PROPOSAL: Two Multiple Dwellings (One New & One Existing)

LOCATION: 12 La Perouse Street, Warrane

12 La Perouse Street, Warrane TAS 7018

Revision D - window/elevation dimensions, privacy clarification and landowner consent package

SITE PLAN

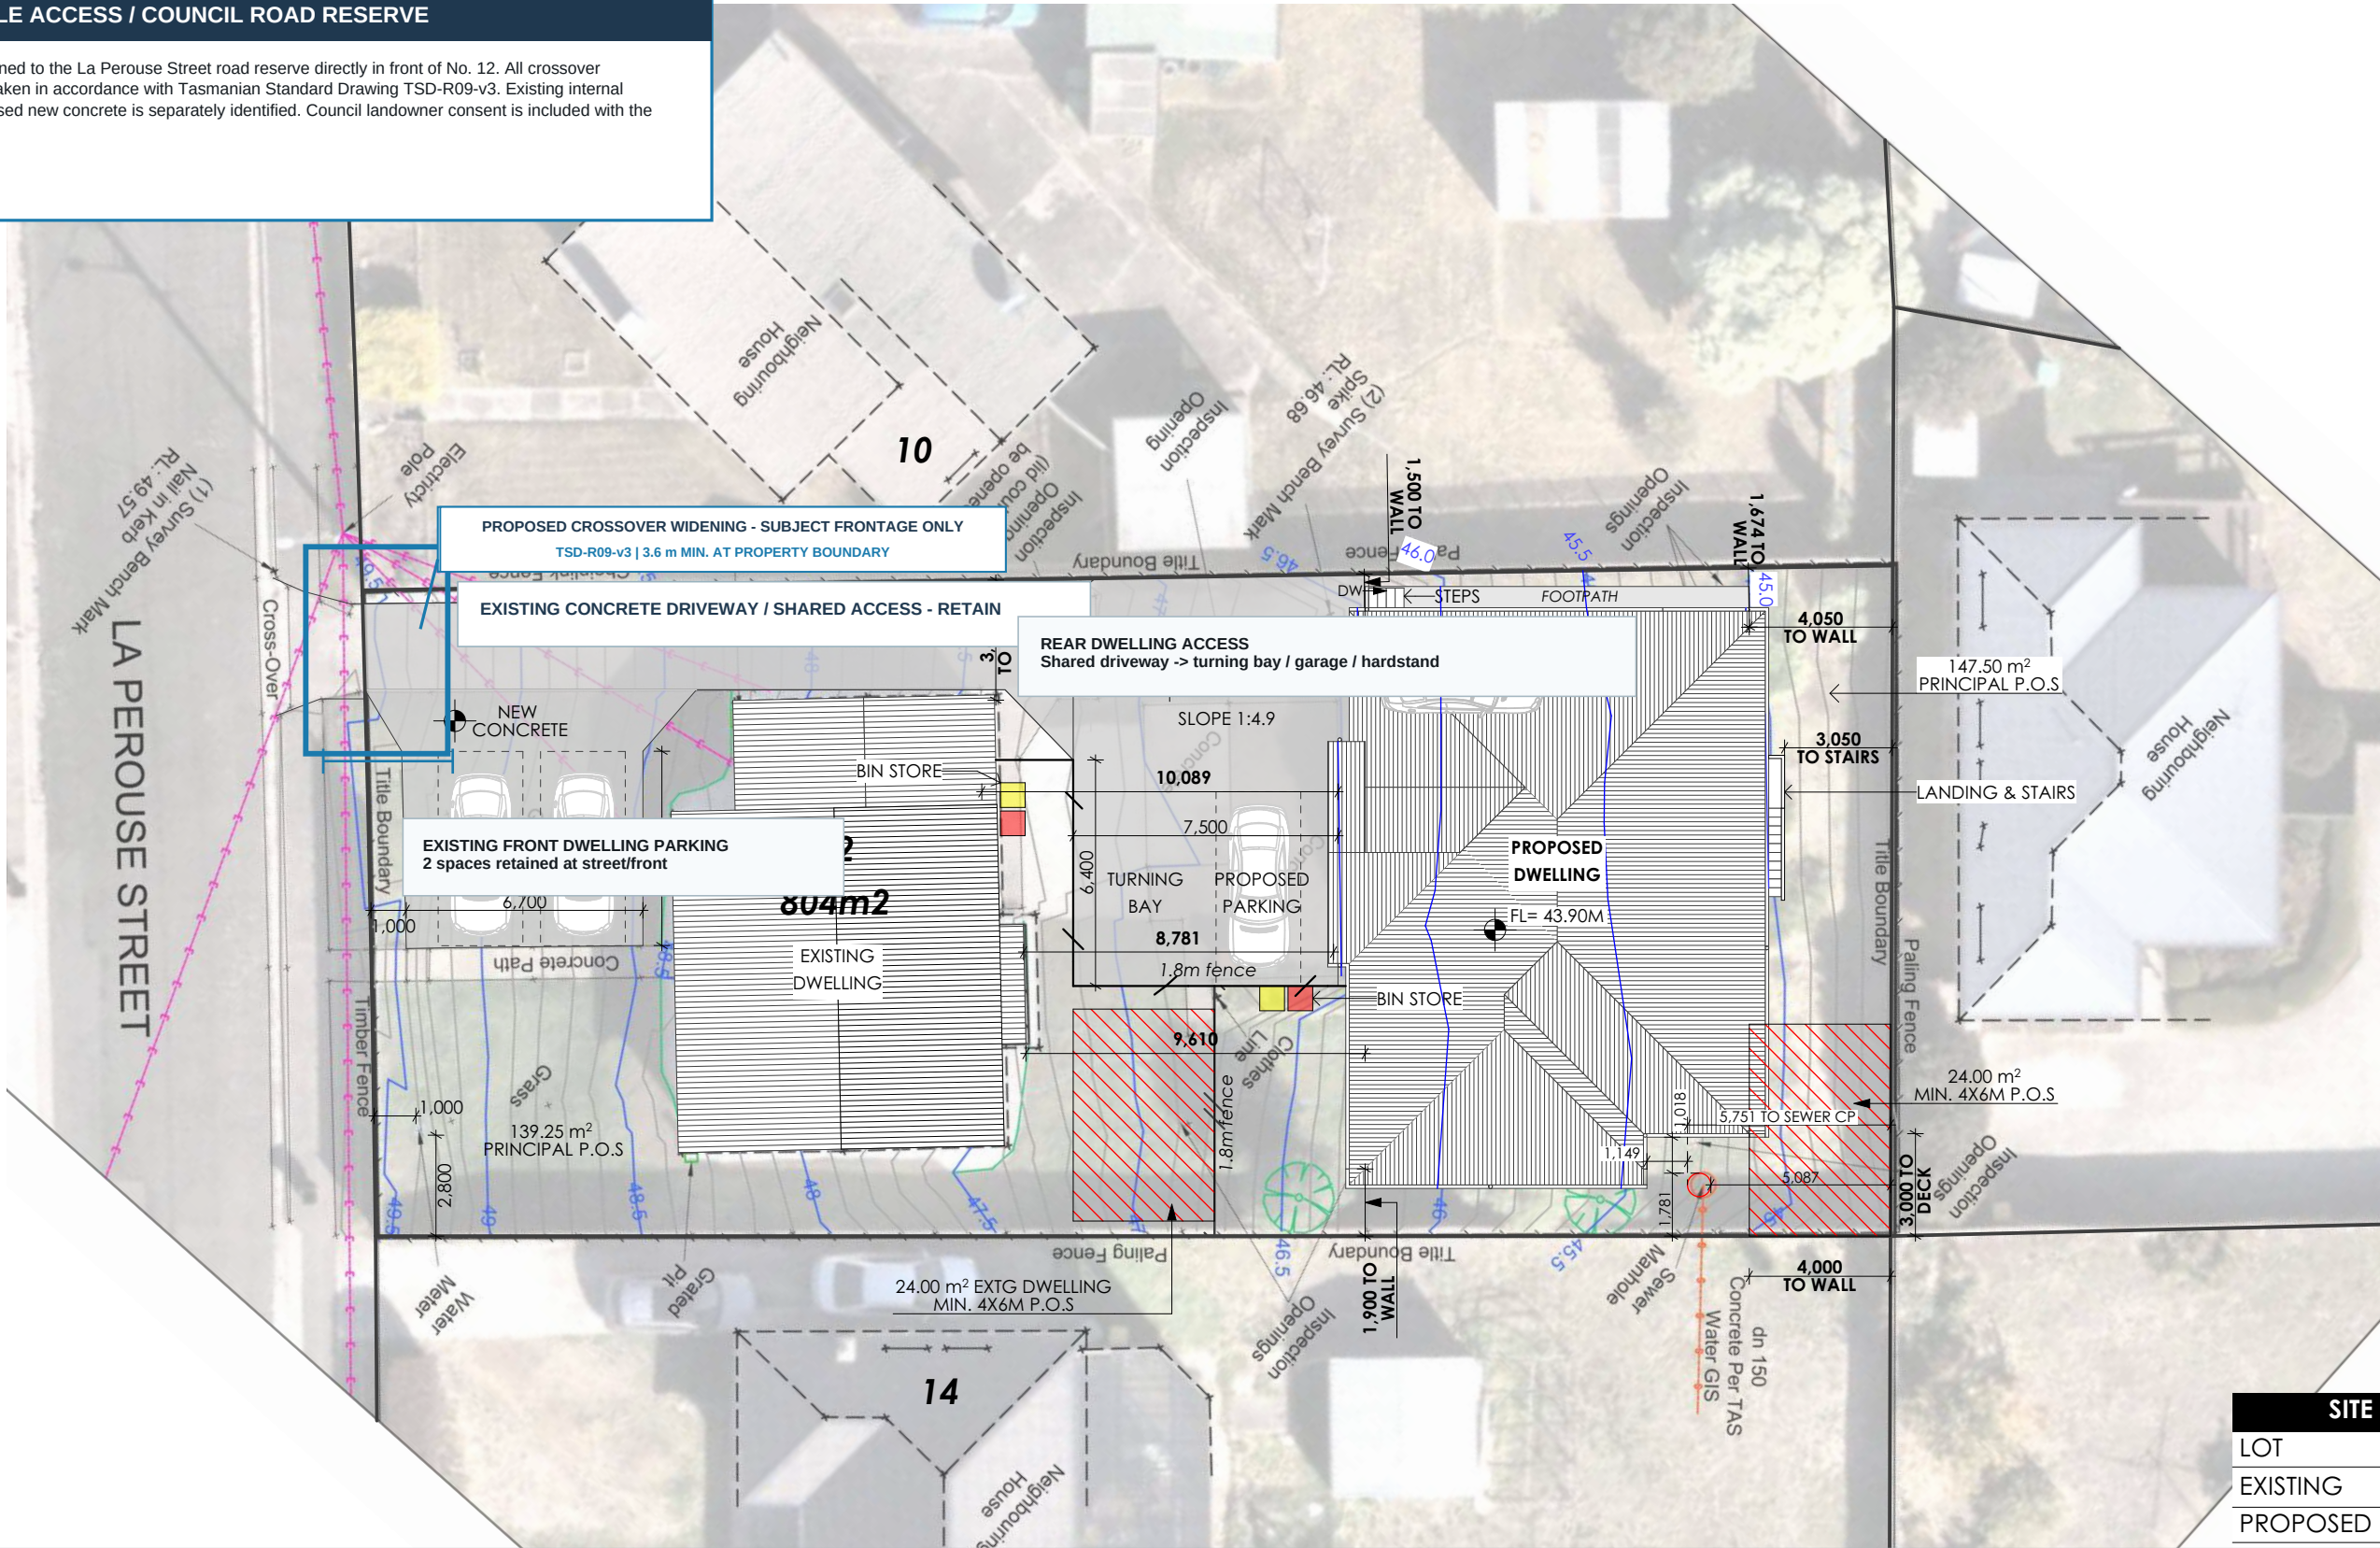
RFI REV D - VEHICLE ACCESS / COUNCIL ROAD RESERVE

Crossover widening is confined to the La Perouse Street road reserve directly in front of No. 12. All crossover alterations are to be undertaken in accordance with Tasmanian Standard Drawing TSD-R09-v3. Existing internal driveway is retained. Proposed new concrete is separately identified. Council landowner consent is included with the RFI submission.

DRIVEWAY / CROSSOVER NOTES: Existing crossover and internal concrete driveway to be retained except where widened at the subject frontage. Proposed road-reserve alteration to TSD-R09-v3, minimum 3.6 m width at property boundary, with final kerb/footpath/levels/services verified to Council requirements. No crossover work is proposed on adjoining properties. Read with RFI-02, B85 manoeuvrability and CT Engineering stormwater/service drawings.

Crossover note revised to TSD-R09-v3; shared driveway and parking allocation clarification added.

FLOOR PLAN

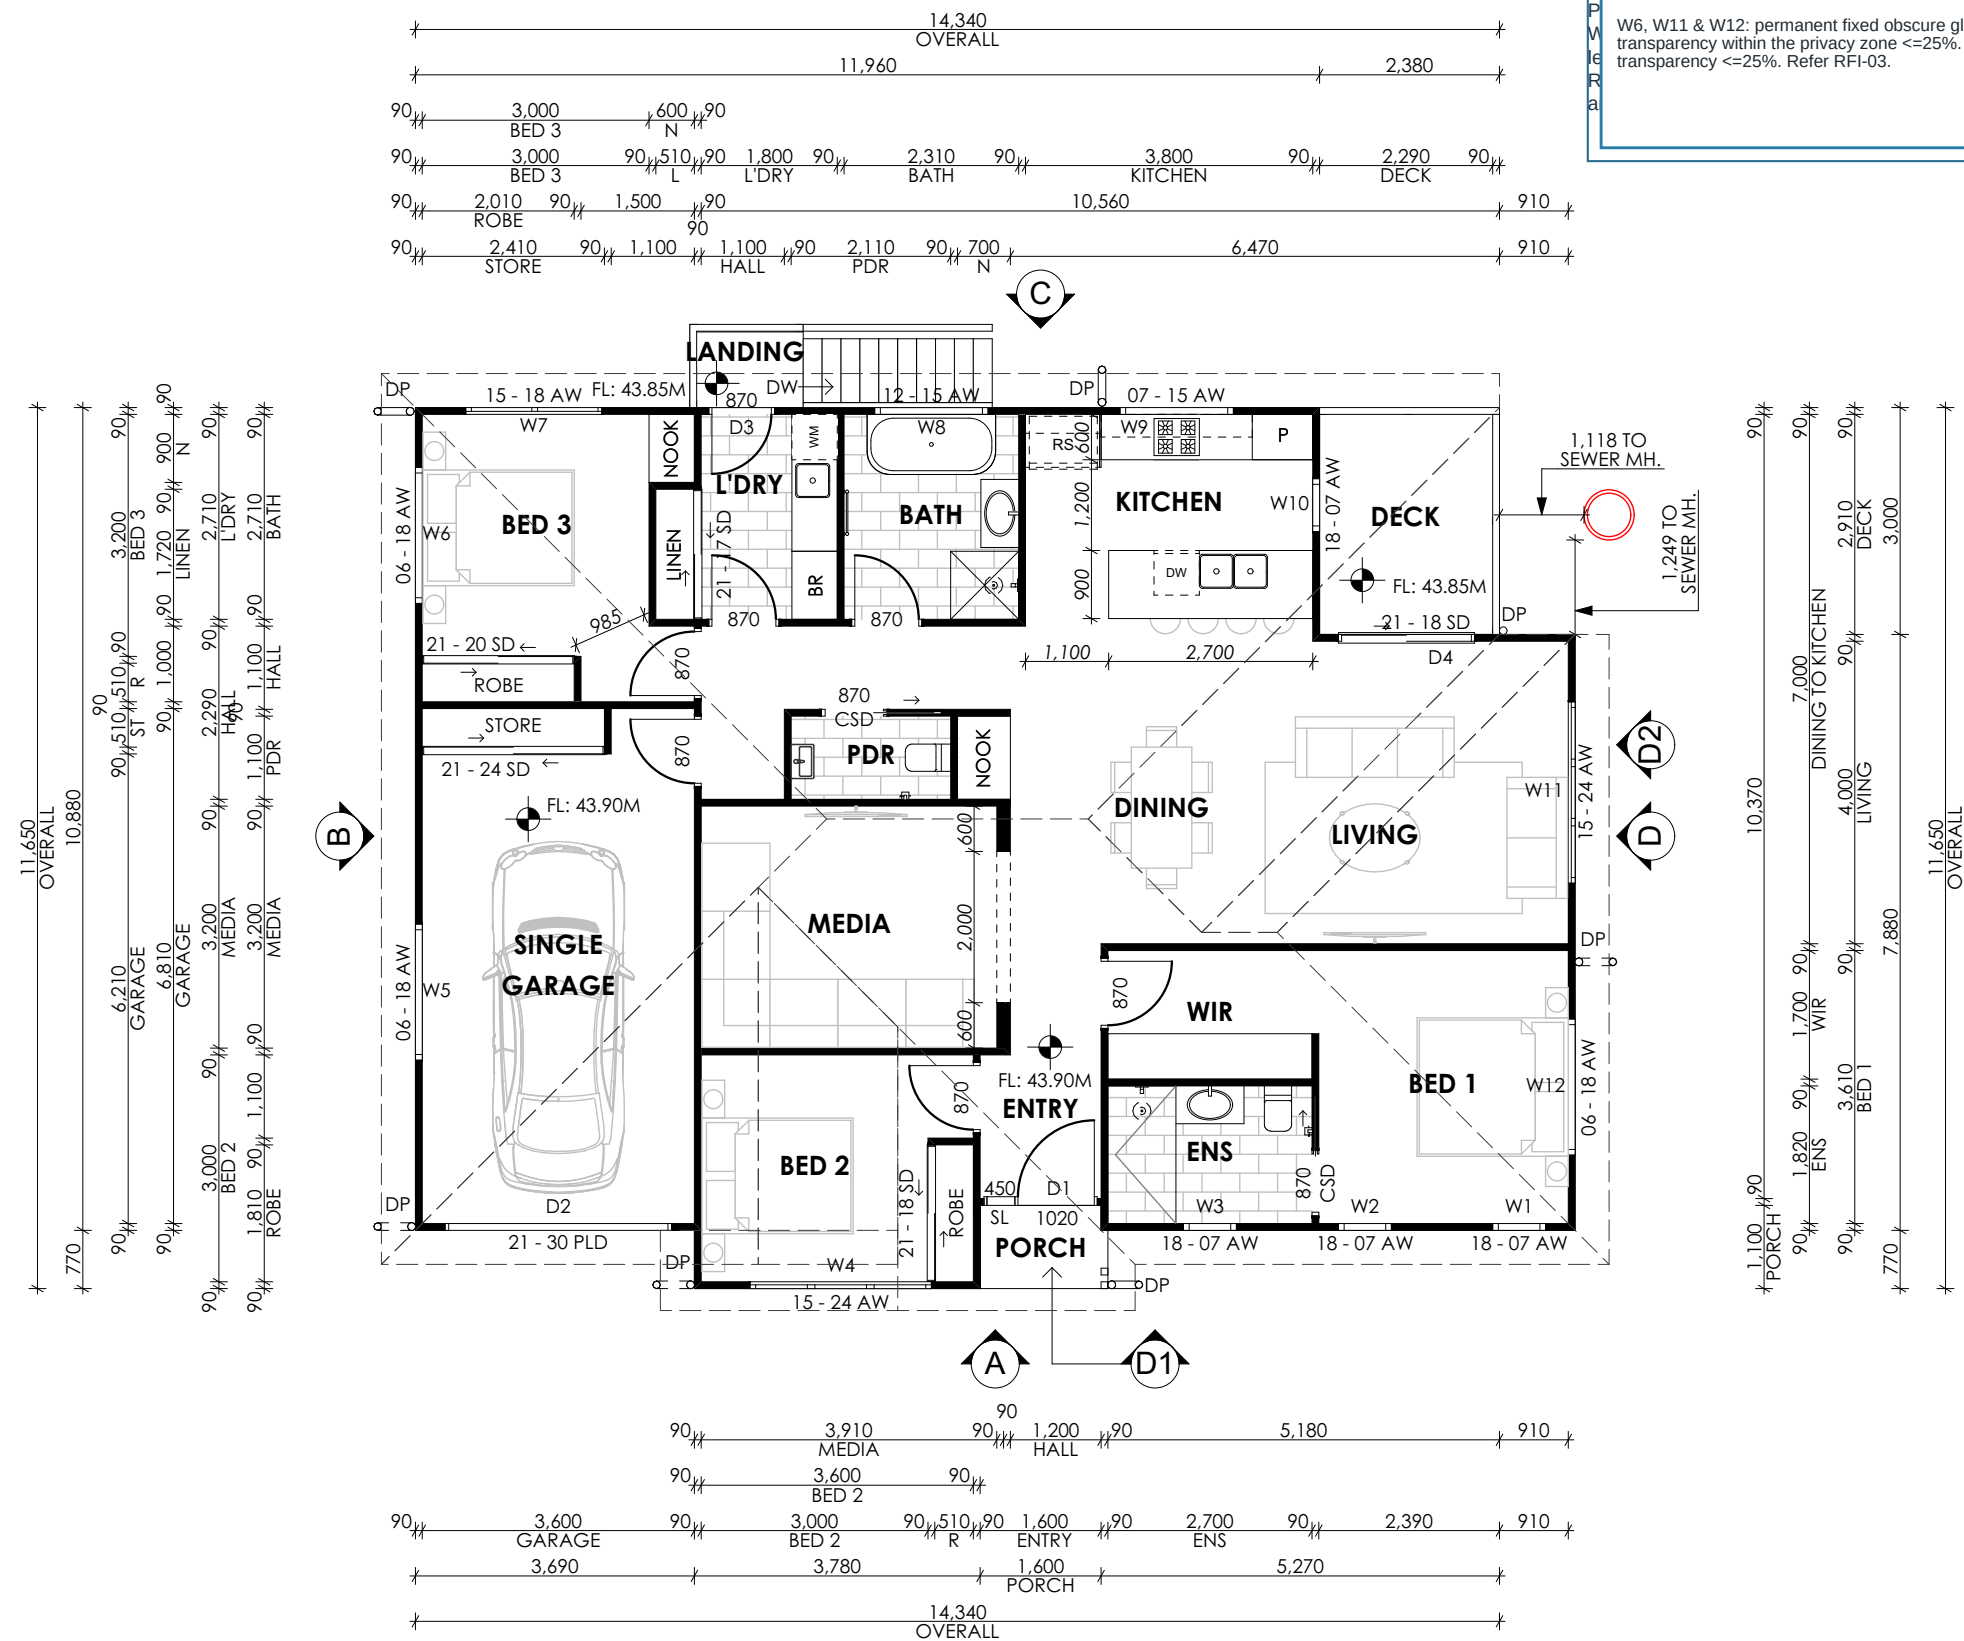
RFI REV C - PRIVACY OVERRIDE

W6, W11 & W12: permanent fixed obscure glazing across full window width to >=1.7 m above FFL. Uniform transparency within the privacy zone <=25%. Rear deck privacy screen: fixed from deck FFL to >=1.7 m high, transparency <=25%. Refer RFI-03.

W6 / W11 / W12 privacy note superseded by this RFI-03: fixed obscure glazing to 1.7 m AFFL and <=25% transparency.

PROPOSED DUAL OCCUPANCY		
WINDOW/DOOR SCHEDULE		
DRAWN: DM	DATE: 26.08.26	REV: B
CHECKED: DM	SCALE: 1:50	
SHEET: 10 OF 15	JOB NO: 4496

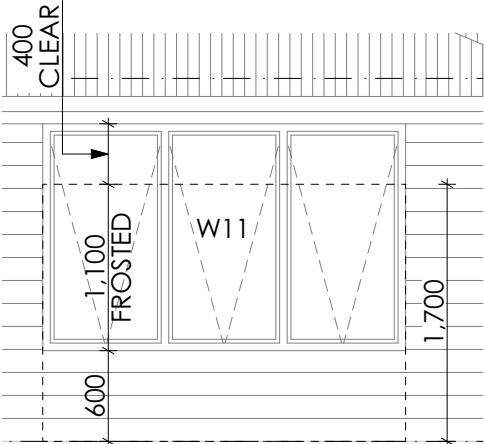
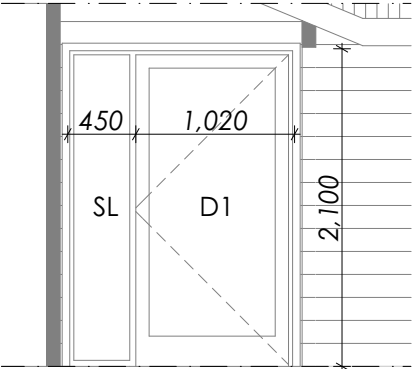
DOOR SCHEDULE							
(ALL ALUMINIUM DOORS TO BE SINGLE GLAZED)							
ID	ROOM	MATERIAL	TYPE	HEIGHT	WIDTH	GLAZING	SCREEN
D1	ENTRY	TBC	HINGED + SIDE LIGHT	2100	1020	TBC	N/A
D2	GARAGE	METAL	PANEL LIFT DOOR	2100	3000	N/A	N/A
D3	LAUNDRY	ALUMINIUM	HINGED	2100	870	CLEAR	N/A
D4	DEC	RFI REV C - WINDOW SCHEDULE OVERRIDE

Notwithstanding the glazing entries in the base schedule: W6, W11 and W12 are to use permanent fixed obscure glazing across the full window width within the privacy zone to >=1.7 m above FFL, with uniform transparency <=25%. Any clear glazing is only above 1.7 m. Refer RFI-03.

Glazing cells are overridden by RFI-03 for W6 / W11 / W12 to avoid any conflict.

NORTH-WESTERN ELEVATION - SHARED DRIVEWAY SIDE

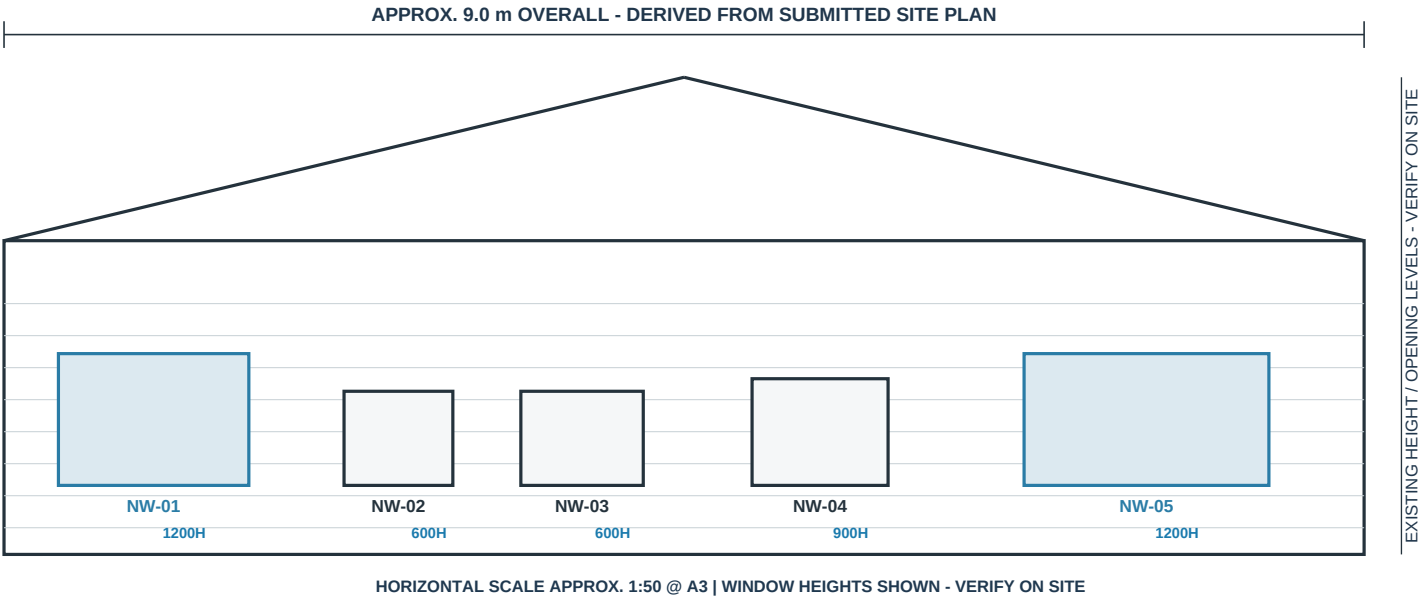
BEDROOM 1 / NW-01: existing finished floor level is 1.20 m above adjacent ground at the rear/NW bedroom window (site advice). Planning sill shown at approx. 900 mm above FFL, giving an indicative sill level approx. 2.10 m above adjacent ground/shared driveway. Existing fixed obscure glazing is retained. NW-05 is the kitchen window and remains a habitable-room opening for planning purposes.

NW-01 Bedroom 1 is a habitable-room window. Existing fixed obscure glazing is retained. Existing FFL at this rear/NW bedroom window is 1.20 m above adjacent ground (site advice); planning sill is shown approx. 900 mm AFFL.
- 3

SOUTH-WESTERN ELEVATION - STREET / FRONT PARKING SIDE

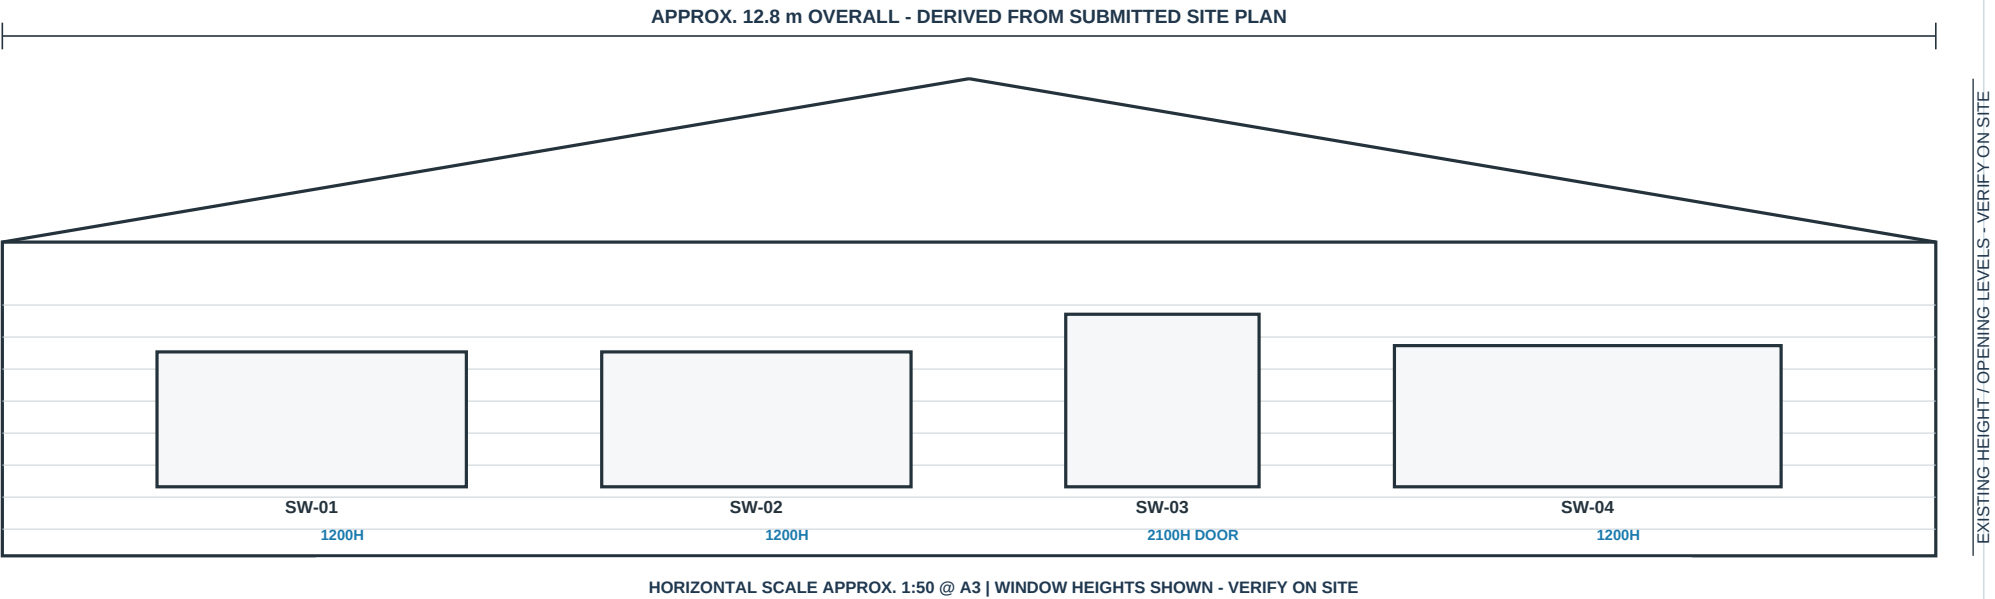
SW elevation openings are existing and retained. Front parking is allocated to the existing dwelling; no rear-dwelling standing bay is proposed immediately against this elevation. All opening positions are shown for Council privacy assessment.
